14-December-2020

Dear Planning Board and Conservation Commission members,

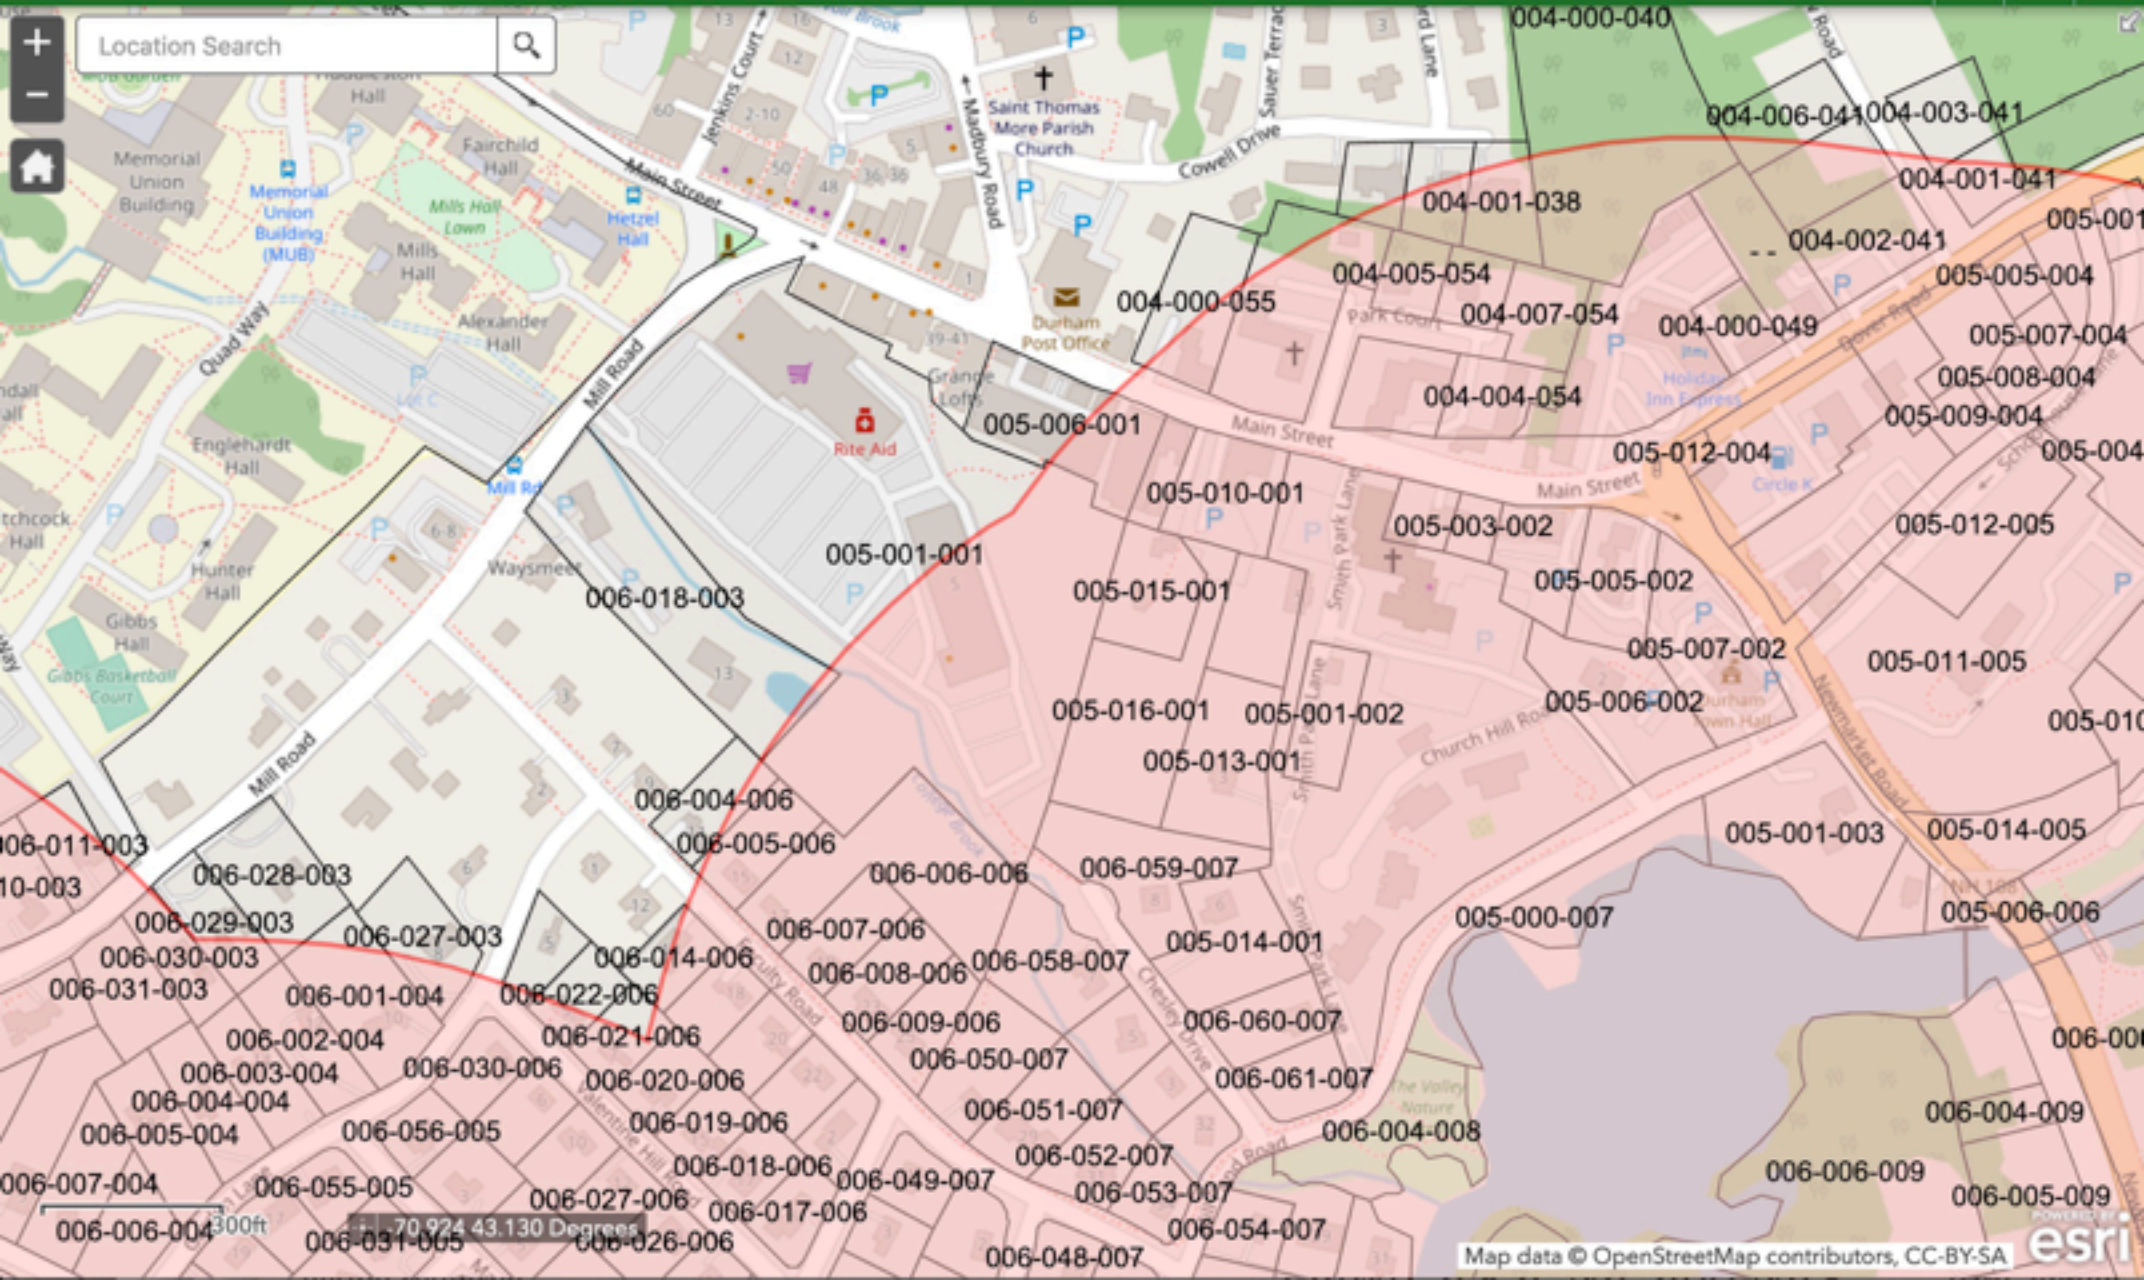
Zooming in on the map at the URL given above yields the details given in the picture attached at the end of this letter.

- (1) In the Mill Plaza proposal, essentially the entire proposed Building C and its retaining wall fall completely within the Oyster River Designated River corridor.
- (2) In the Church Hill proposal, all the lots included in the proposal fall completely within the Oyster River Designated River corridor.

Therefore the Oyster River LAC must be notified independently by each proposal. See the Oyster River LAC web site at URL *<http://oysterriverlac.org/oysterriver.html>* for details on the Oyster River Corridor Management Plan from 2014, various documents, and maps. The Oyster River LAC is chaired by Eric Fiegenbaum of Madbury, and has local members from the towns of Barrington, Lee, Madbury, and Durham. The Durham members are Michael Sullivan, Jim Hornbeck, and Stephen Burns. I would therefore urge both the Planning Board and the Conservation Commission to contact Mr. Fiegenbaum and the Durham LAC members for insights on these proposals.
